GROWTH MANAGEMENT DEPARTMENT STAFF REPORT
VILANO BEACH TOWN CENTER OVERLAY DISTRICT

VBTCDR 2022-07 Vilano Beach Gateway Feature Mosaic Beautification

To: North Coastal Design Review Board
Staff: Sloane Stephens, Planner
Date: October 3, 2022

Proposed Enhancements (Northern Face)

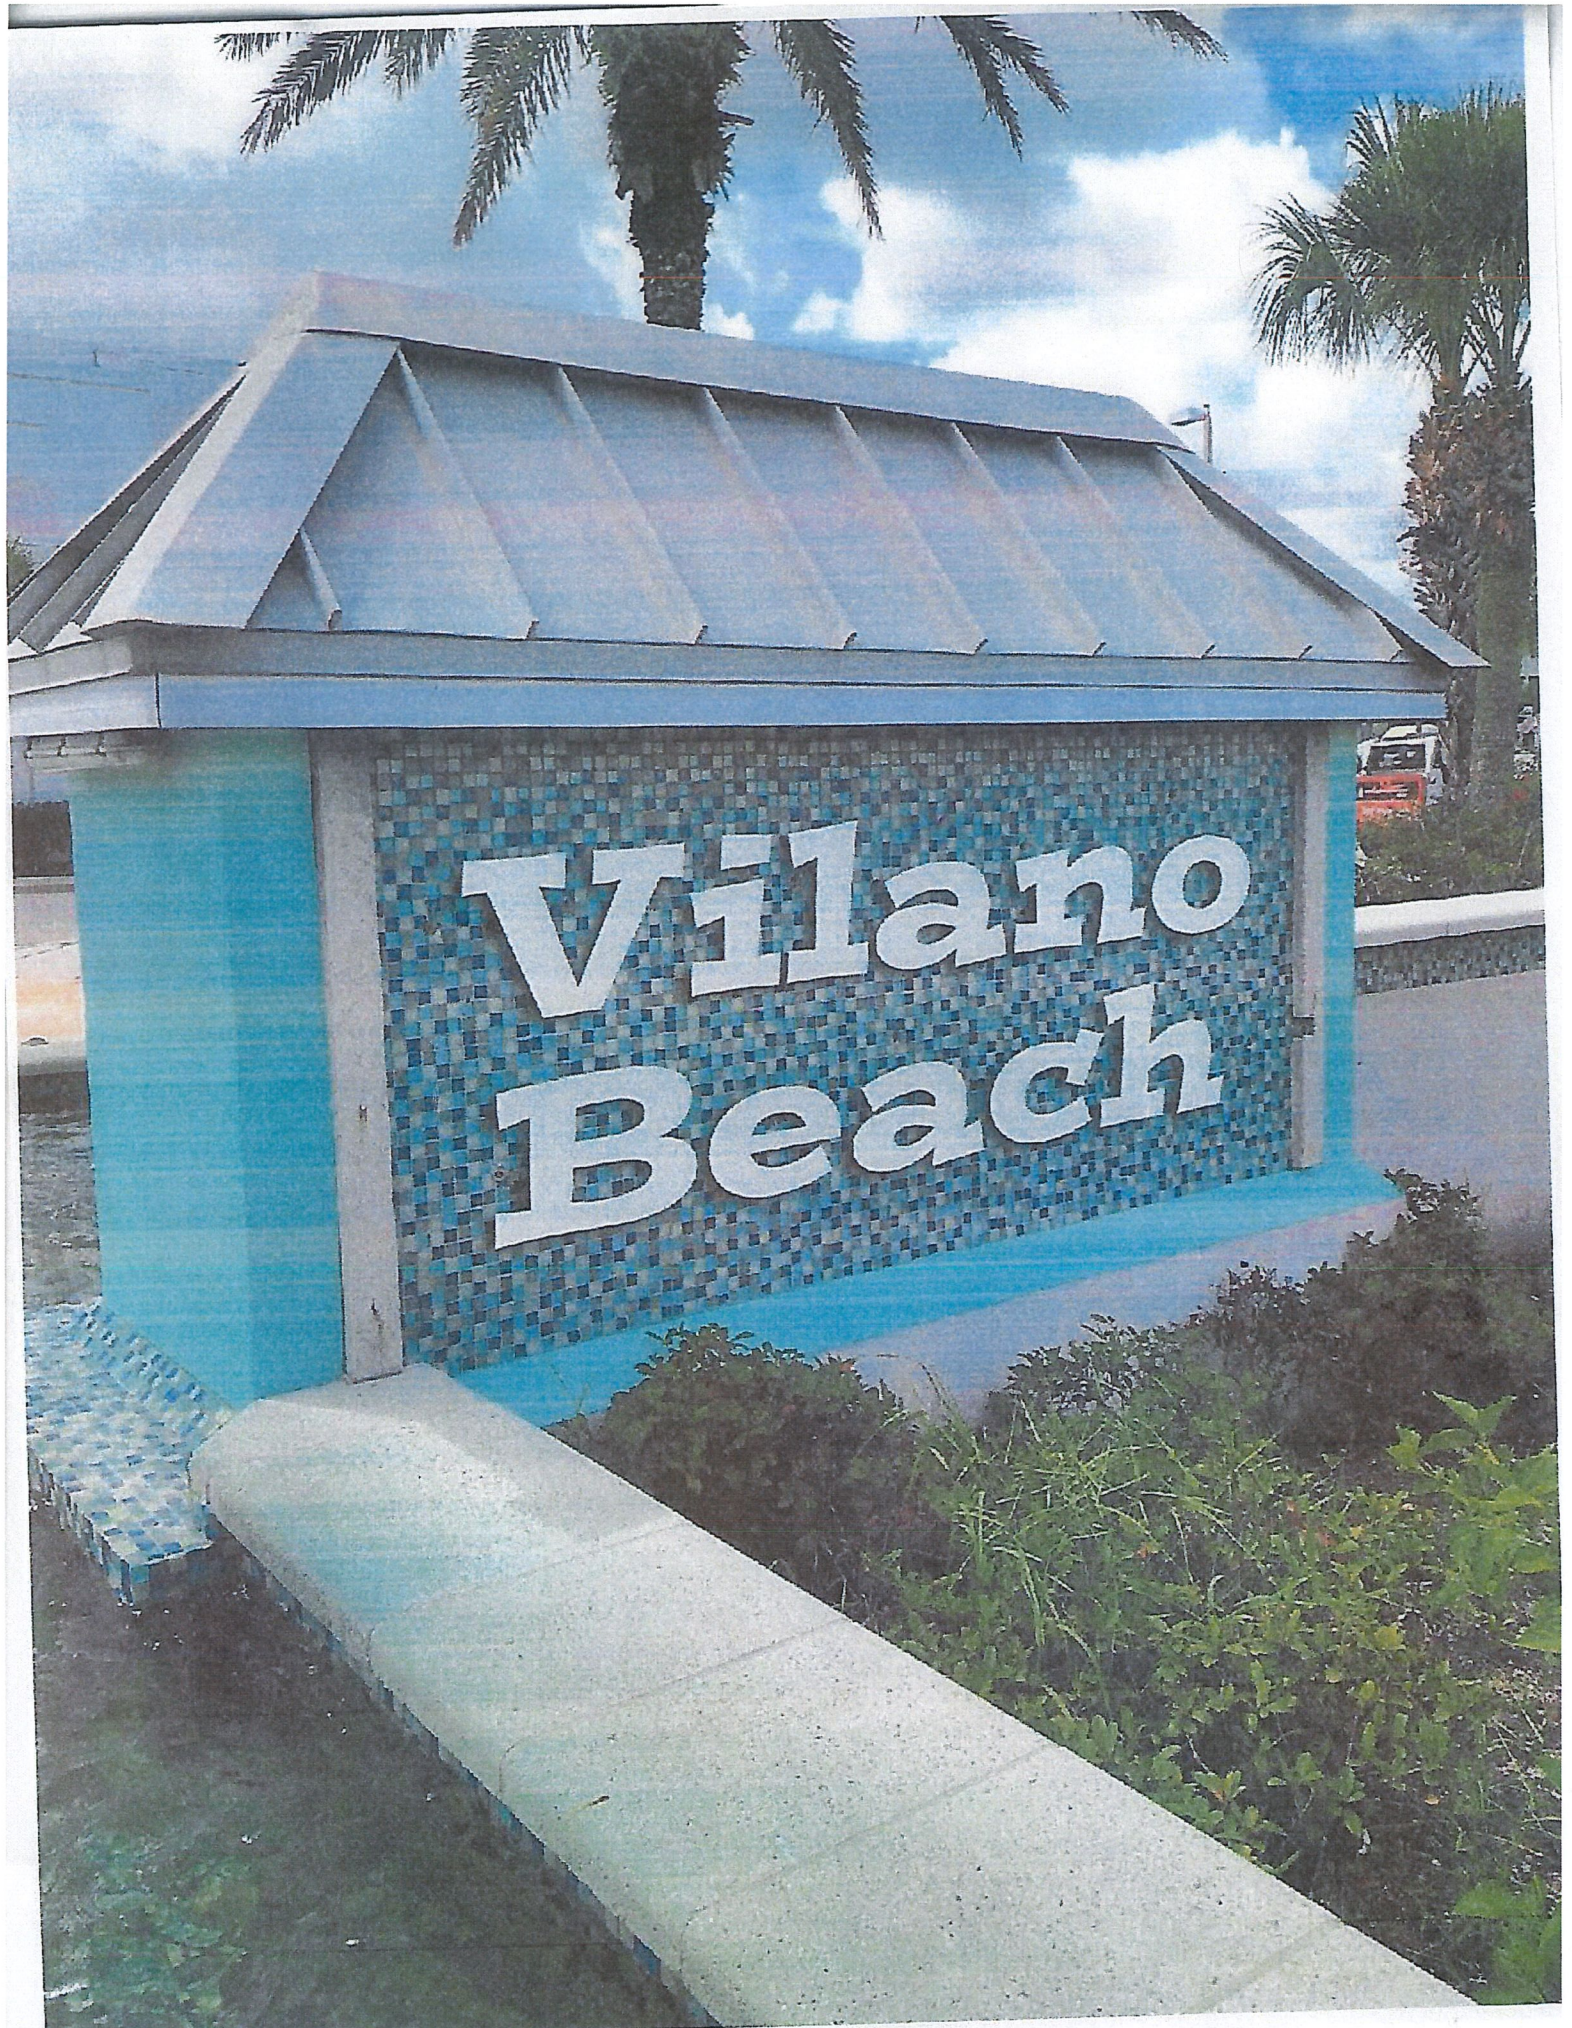
- b. Signs must be professionally designed, lettered and constructed.
- c. Wall Signs shall be mounted directly upon wall surfaces, and shall not be mounted upon raceways or other protrusions from the wall surface. *Rendering shows “Vilano Beach” lettering shall be mounted directly on the face of the monument sign.*

- e. Signs may be illuminated as provided by Article VII of this Code, however when Signs use exterior lighting, such lighting must be concealed and shielded with hours of illumination to cease no later than 30 minutes after business closing, unless additional time is approved by the DRB. *Supporting document states up lighting will be provided at a future date. Please note: if lighting is proposed in the future, the DRB may want an opportunity to approve.*

1. Signs must be professionally designed, lettered and constructed.
2. All installation components or hanging devices such as, but not limited to, fasteners, clips, bolts, etc. shall be of a non –corrosive, stainless steel, aluminum, brass or bronze; carbon bearing steel shall be of non-ferrous metal of quality material and finish. All fasteners shall be concealed. All black iron materials shall be finished to withstand corrosion. All penetrations to the fascia shall be neatly sealed in a watertight manner using a single component silicon sealant. All signage shall have an individual circuit and be controlled by a time clock. Exposed conduit or electrical wiring is prohibited.
